# PCN – Product Change Notification

PCN-A-110901

PCN Topic: Update 7 inches Chassis Monitor Drawing\_W07T740-CHA2

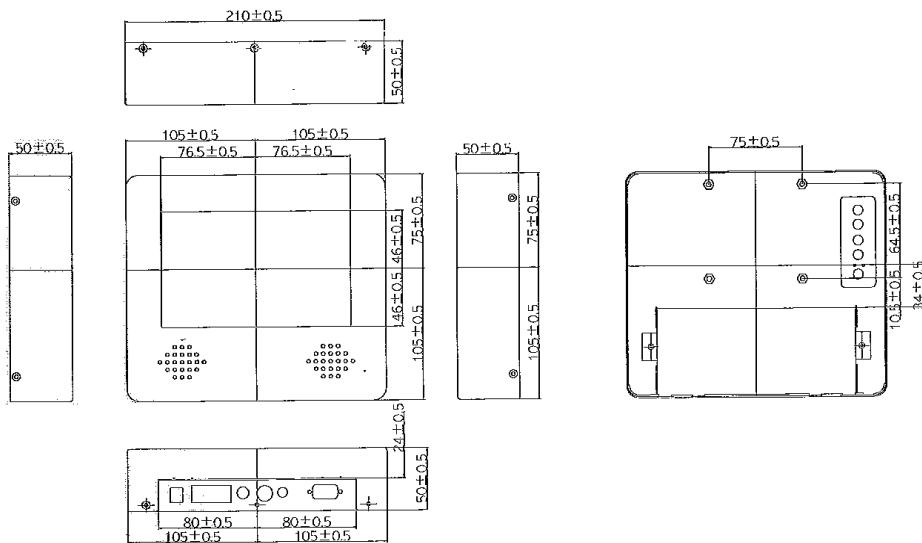
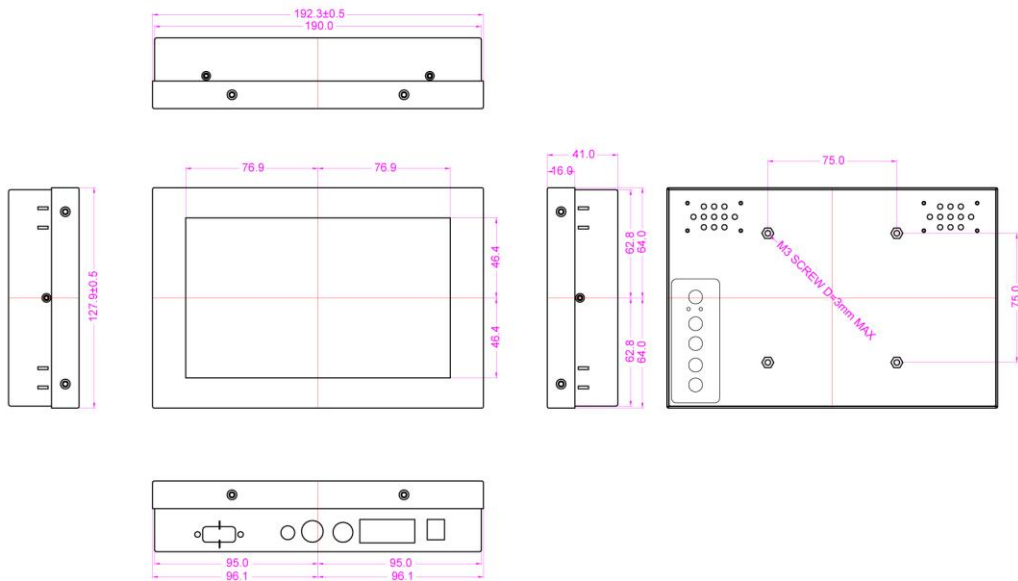
Due to the use of new panel, we would like to inform you about our Product changes on the product drawing.

The dimension of this model will be changed from 210\*180 (W\*D) to 192.2\*128.
